2016 Corvette: Service Bulletin: Delayed Engagement After Sitting With Engine Off

#16-NA-014: Delayed Engagement After Sitting With Engine Off - (Jan 21, 2016)

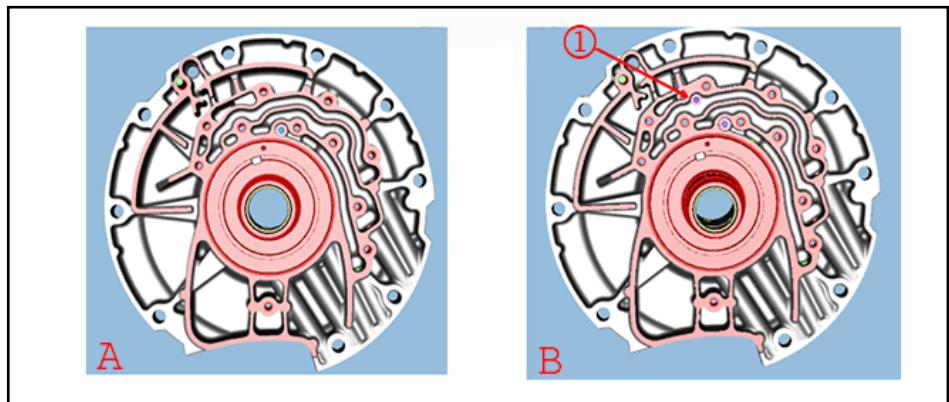
(A)

Old stator support asm 242
74636/24275106/2427265
6

(B)

New stator support asm
24277234

Note: The new stator shaft support assembly has a second check ball (1) added (see illustrations).

Install a new stator shaft support assembly that includes an additional check ball. Follow the instructions below to replace the stator shaft support assembly.

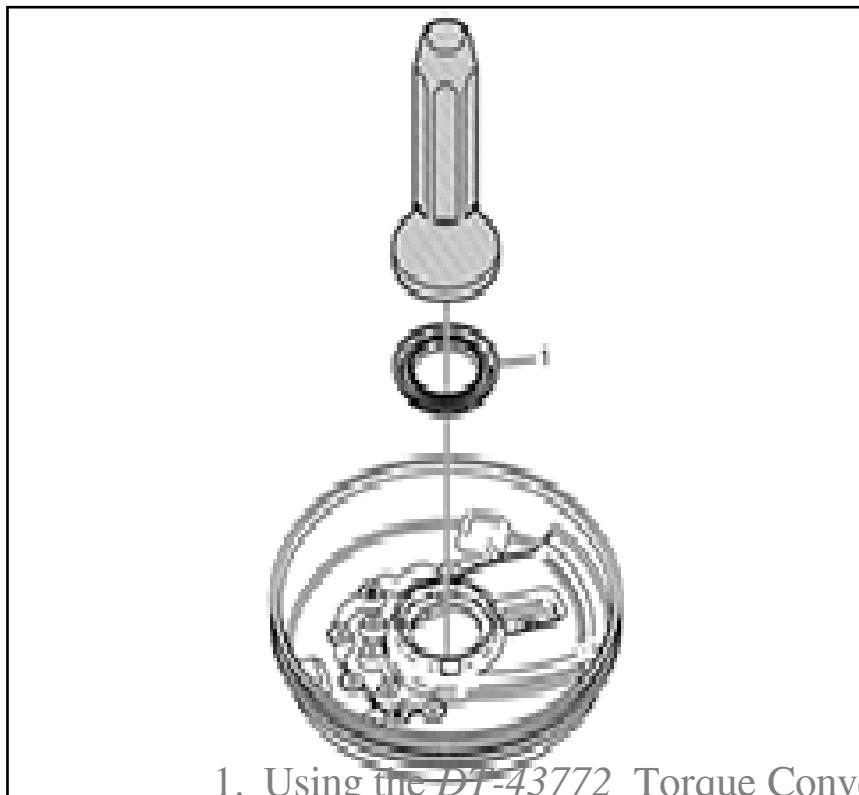
(A)

(B)

Old cover 24272660

New cover 24277964

Note: The casting void has been eliminated from the underside of the cover (see illustration).
